**PLEASANT PRAIRIE PLAN COMMISSION MEETING
VILLAGE HALL AUDITORIUM
9915 39th AVENUE
PLEASANT PRAIRIE, WISCONSIN
6:00 P.M.
May 29, 2018
AGENDA**

VILLAGE STAFF REPORT OF MAY 29, 2018

SUBJ: Parcel 32 Industrial Building
Civil Engineering Plans

ENG REVIEW
PLAN MARK-UP
MAY 21, 2018

SHEET
C-1
of
C-10

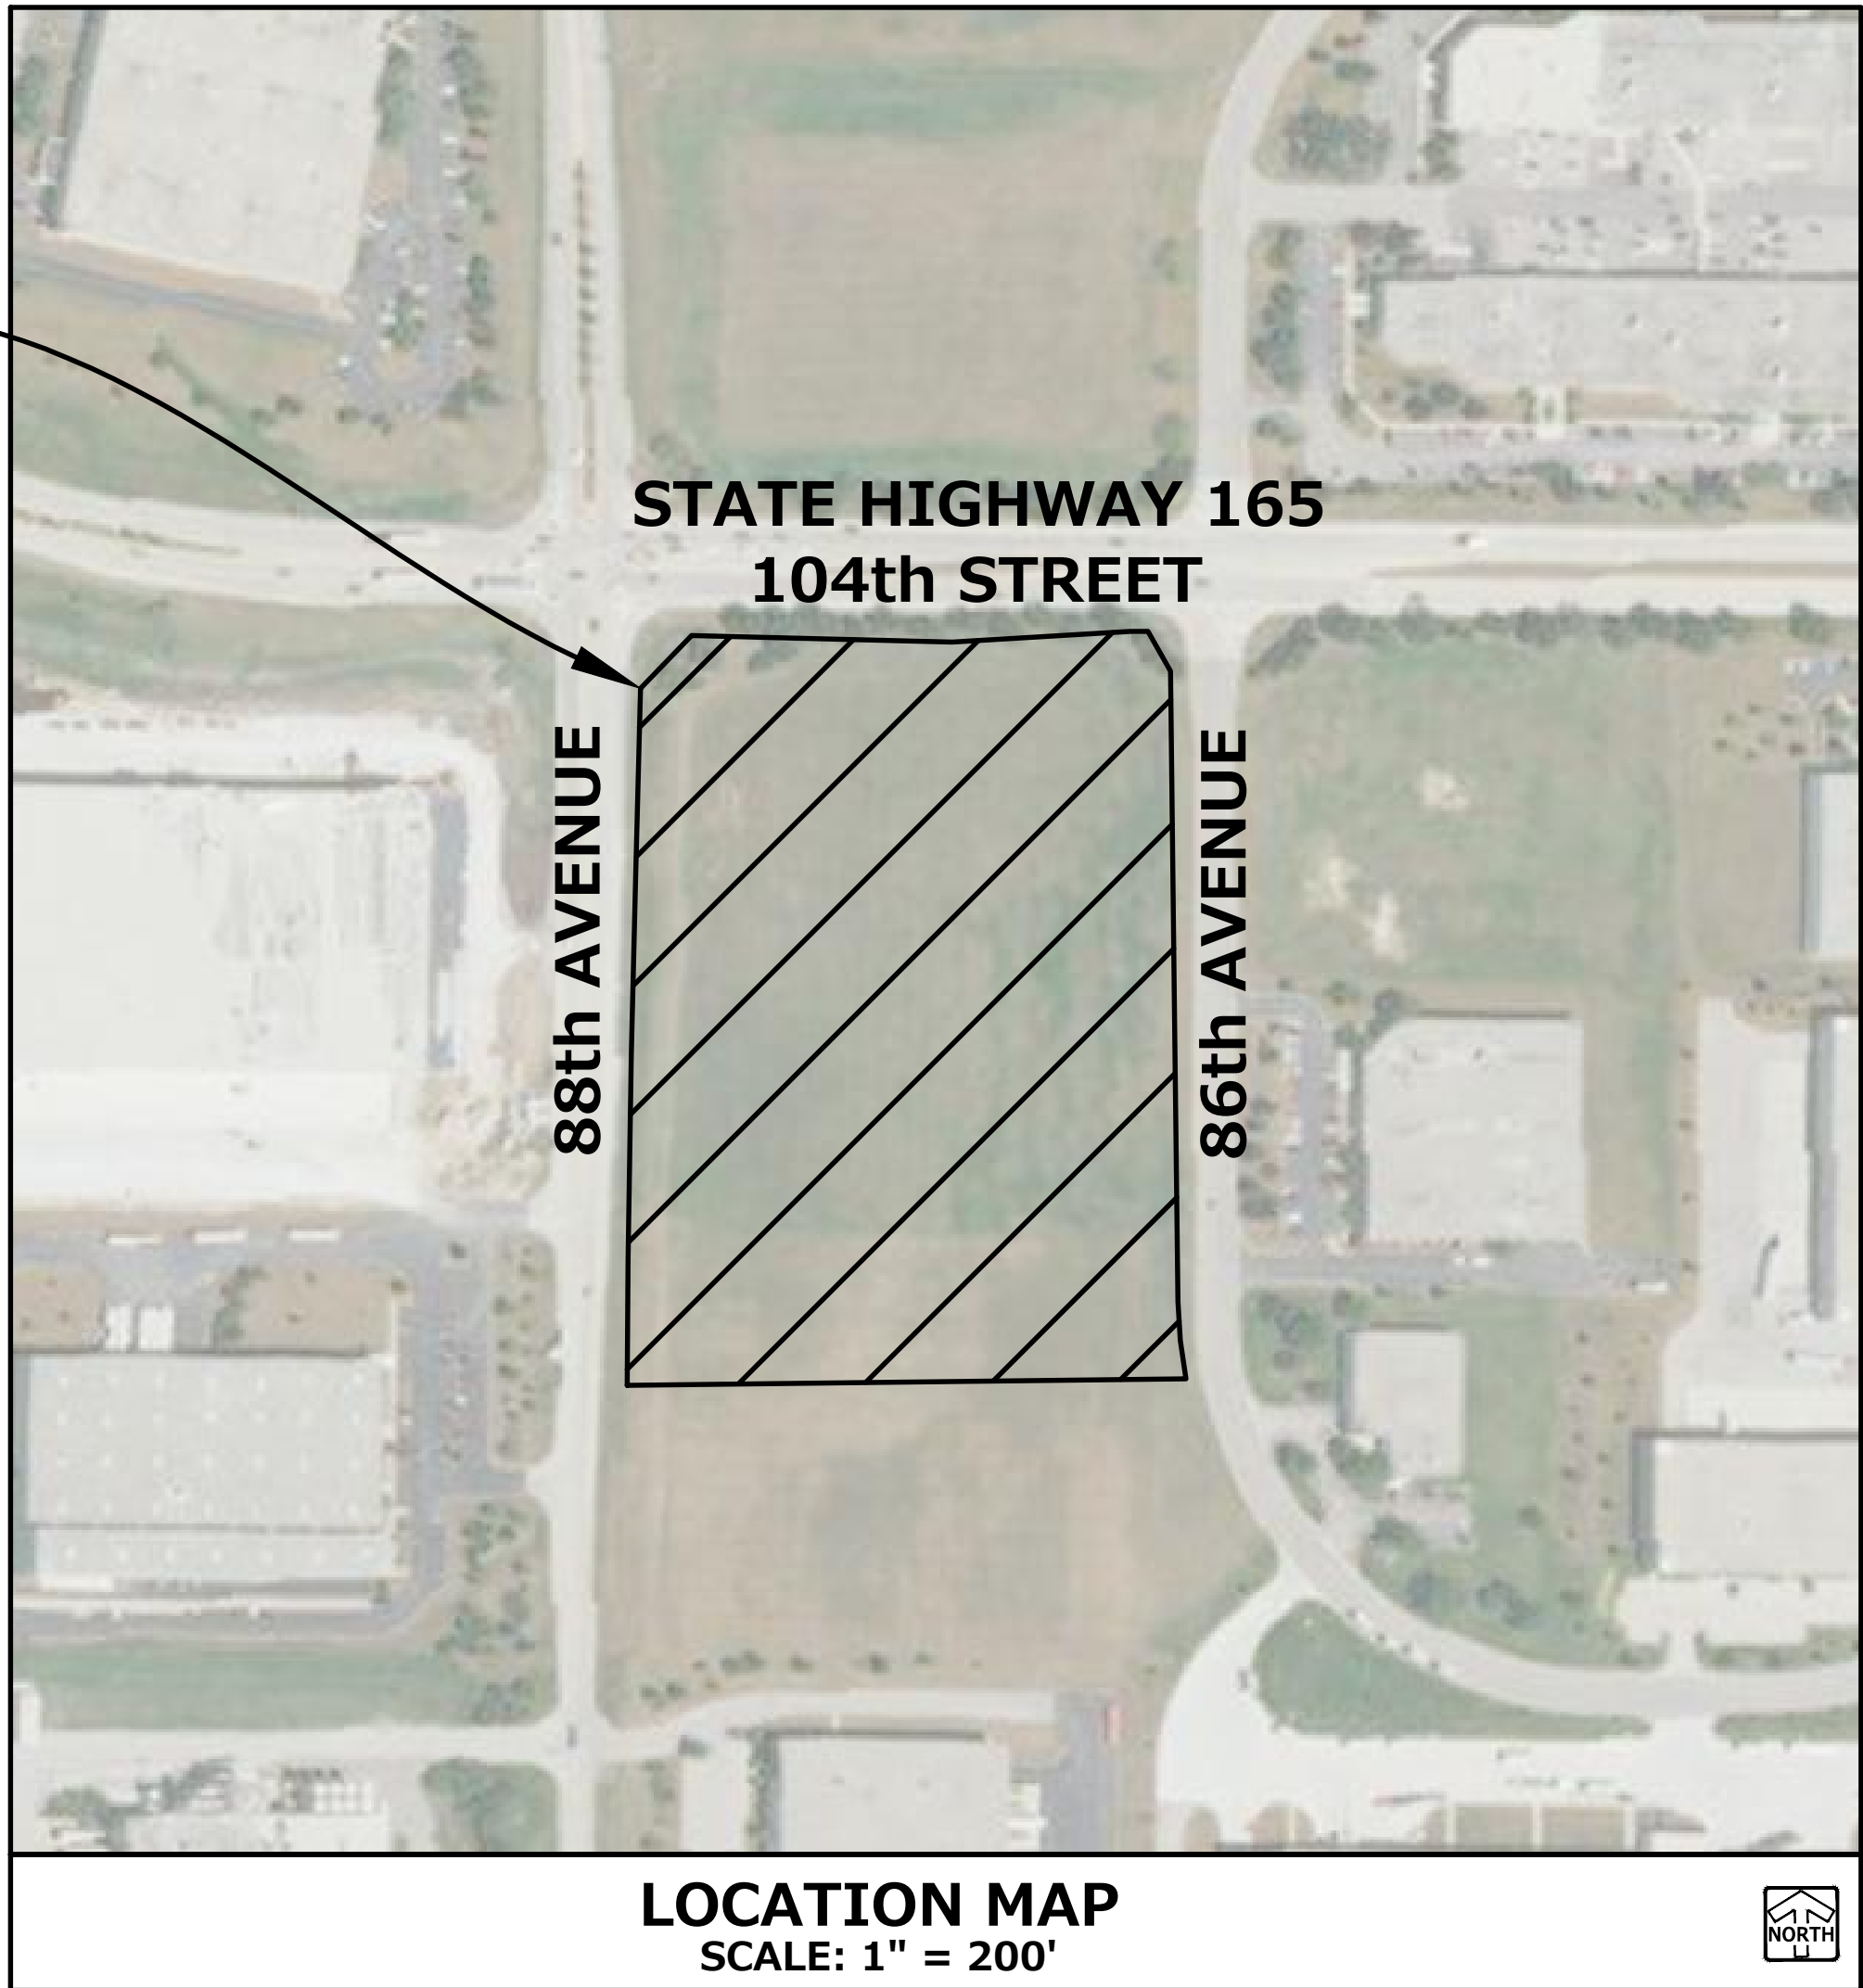
ADD VILLAGE STANDARD
PRE-CONSTRUCTION
CONFERENCE NOTE

1 ARCHITECTURAL SITE PLAN
SCALE 1" = 50'-0"

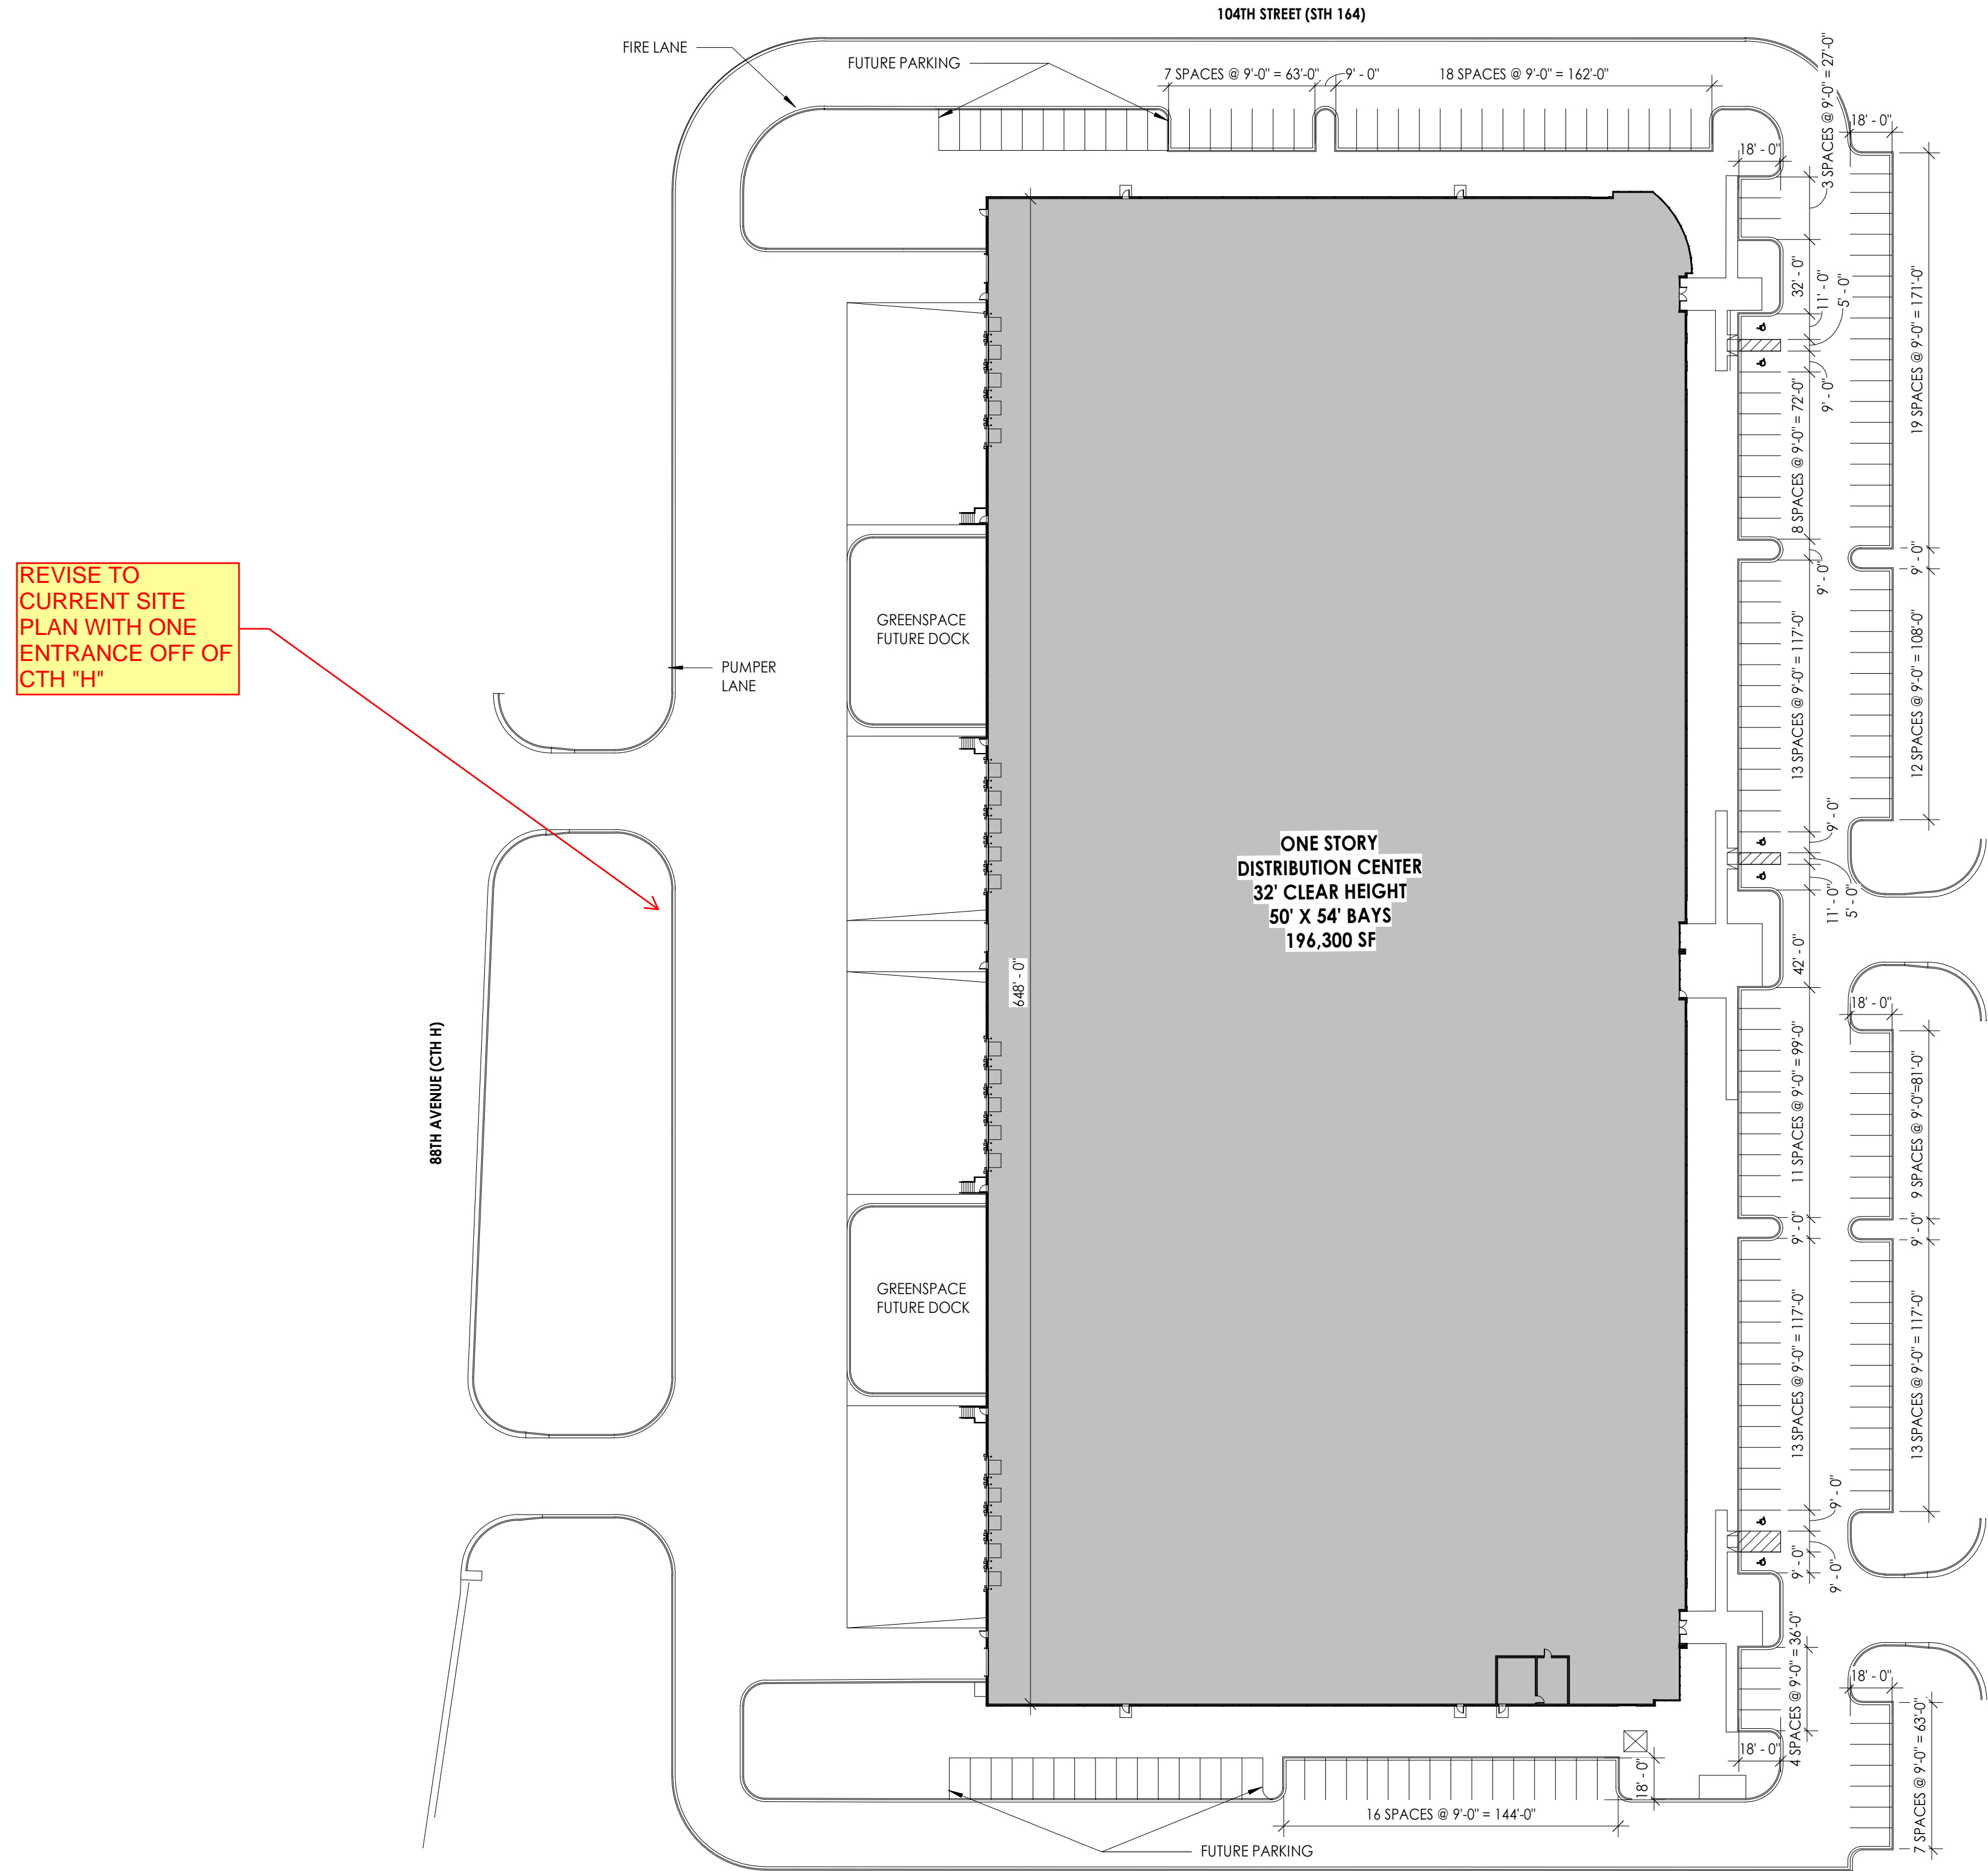
- p. Provide a site irrigation plan.
 - q. The site plans within the architectural plan set shall be revised to match the civil plans. In addition, any other building plans and elevation labels shall be correct as well.

- r. Correct the site summary information sheet A050.
 - s. The parking lot lighting plan including the photometric plan shall be revised to match the civil plans.
